FLOWER CHILD
1900 CROCKER ROAD
WESTLAKE, OH 44145

Drawing No: 26-0313-R01

Page No: SP1.02

1 FLOOR PLAN
SCALE: NTS

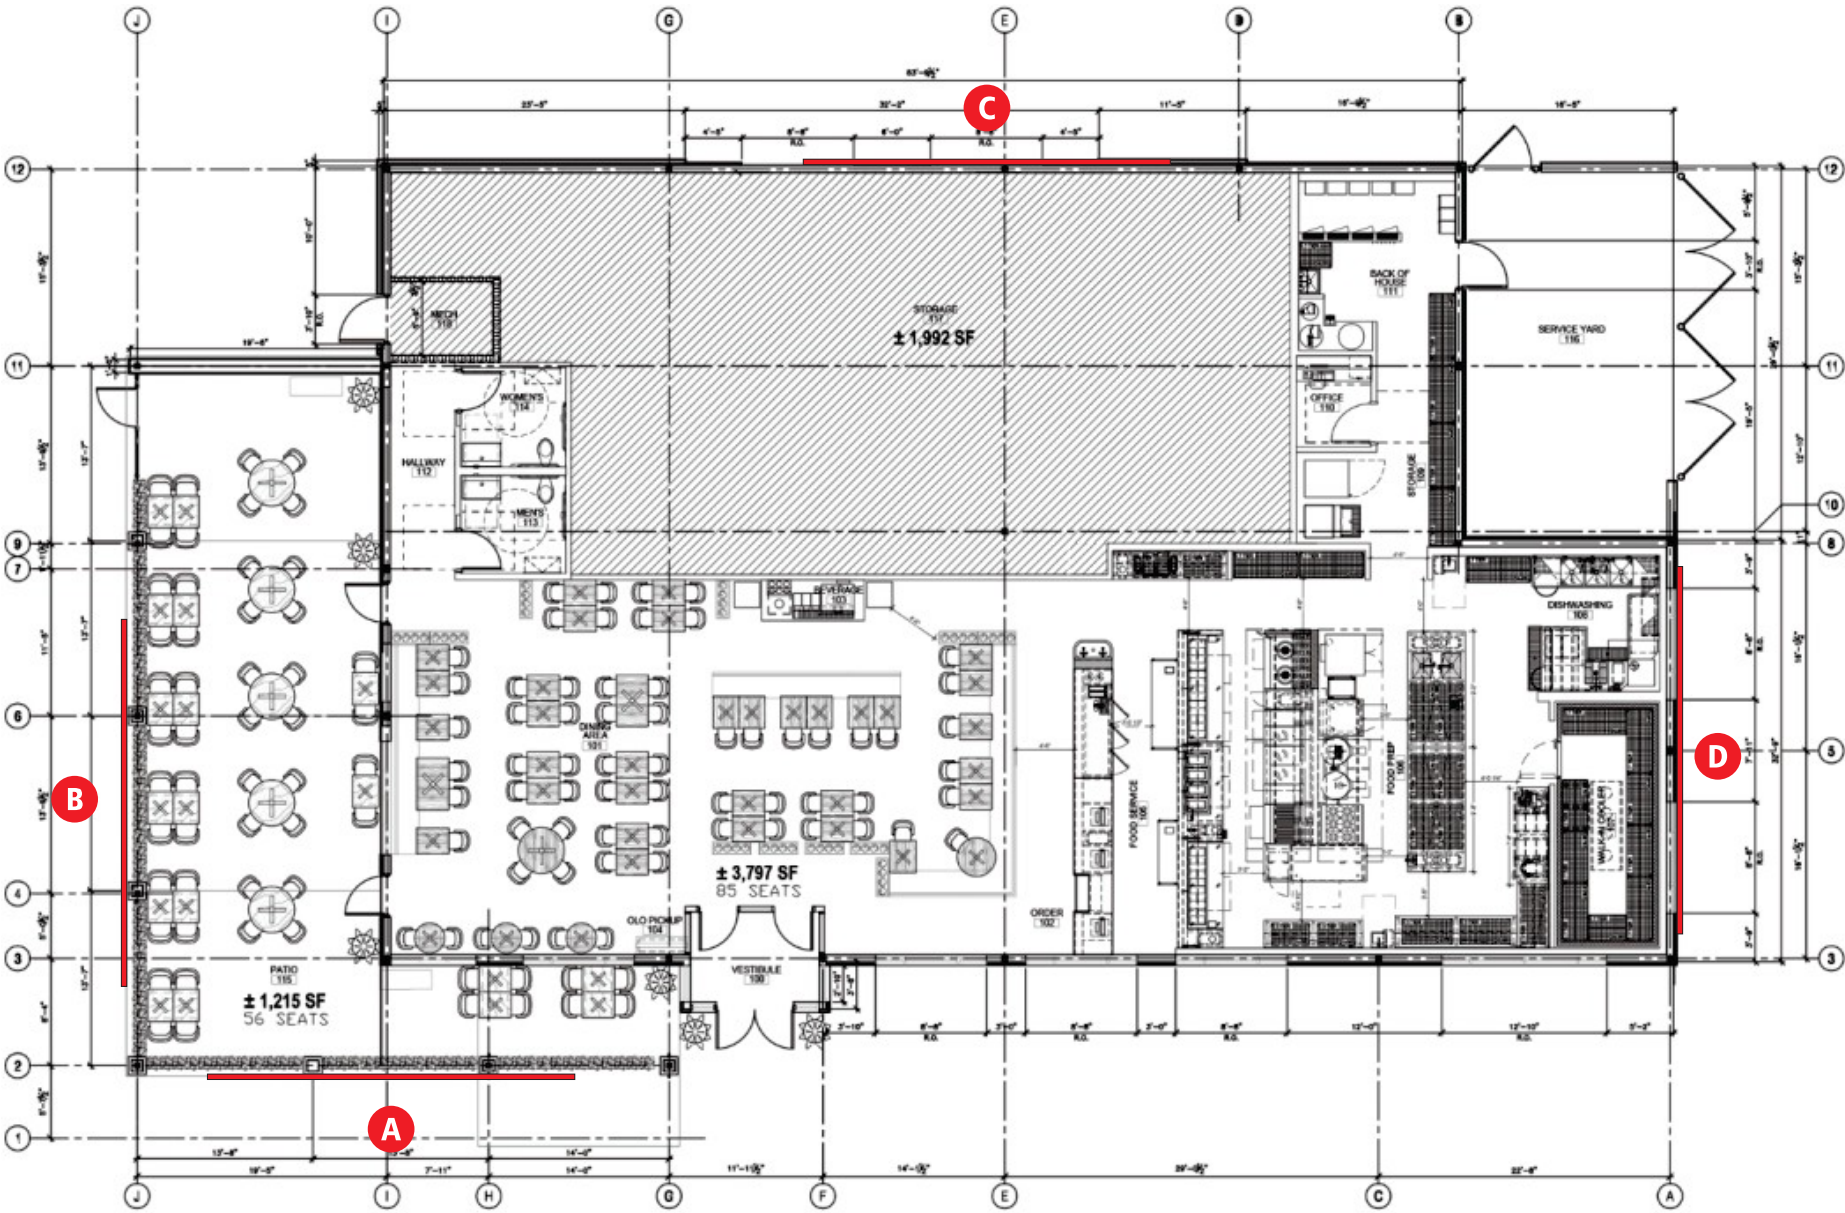
1)PM-08.07.26:Update C/D to painted letters
